CITY PLAN COMMISSION

FILE NUMBER: S223-257

REQUEST: An application to create one 11.711-acre lot from a tract of land in City Block A/8375 on property located on Ryan Road at Luna Road, southeast corner.

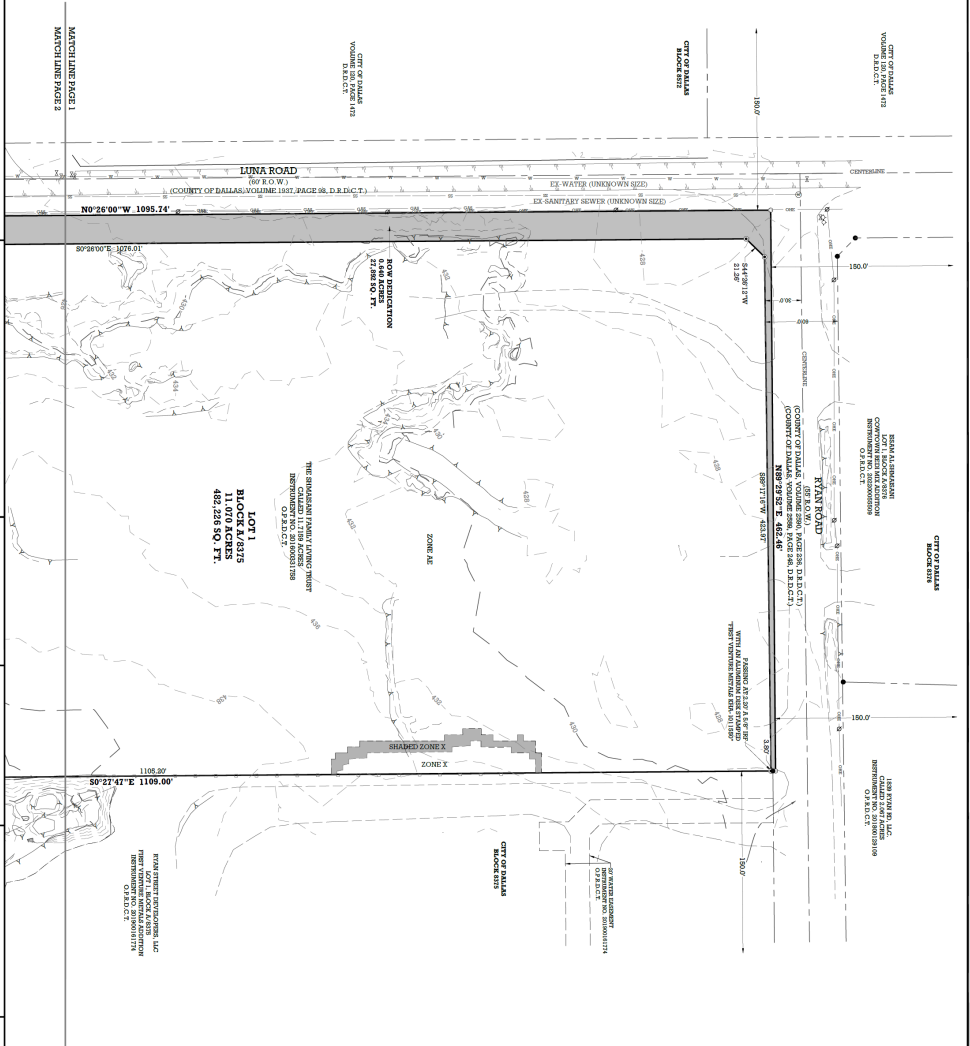
15. On the final plat, dedicate 53.5 feet of right-of-way (via fee simple) from the established center line of Luna Road. Section 51A 8.602(c).
16. On the final plat, dedicate 30 feet of right-of-way (via fee simple) from the established center line of Ryan Road. Section 51A 8.602(c).

17. On the final plat, dedicate a minimum 20-foot by 20-foot corner clip (via fee simple or Street easement) at the intersection of Luna Road and Ryan Road. Section 51A 8.602(d)(1).

19. Construct one-half of the Luna Road thoroughfare requirements along the entire length of the proposed plat per the City of Dallas standard. Section 51A-8.604(b)(3)

20. Provide 20 feet all-weather paving material for Ryan Road along the proposed plat per the City of Dallas standard. Section 51A-8.604(b)(2)
21. Must coordinate with Transportation Department for any traffic signal requirements that are deemed necessary for improving pedestrian accessibility and safety related to site development. (contact Srinivasa Veeramallu with Traffic Signals) Section 51A-8.606, 51A-8.608

22. On the final plat, determine the 100-year water surface elevation across this addition.
23. On the final plat, dedicate floodway easement, floodway management area or floodway easement (within common area), with the appropriate easement statement included on the face of the Plat. 51A 8.611(d); DWU Floodplain Management; Drainage Design Manual Addendum V

25. On the final plat, specify minimum fill and minimum finished floor elevations. *Section 51A-8.611(d), Trinity Watershed Management.*
26. On the final plat, show the natural channel set back from the crest of the natural channel. *Section 51A-8.611(d), Trinity Watershed Management.*

37. On the final plat, identify the property as Lot 2 in City Block A/8375.
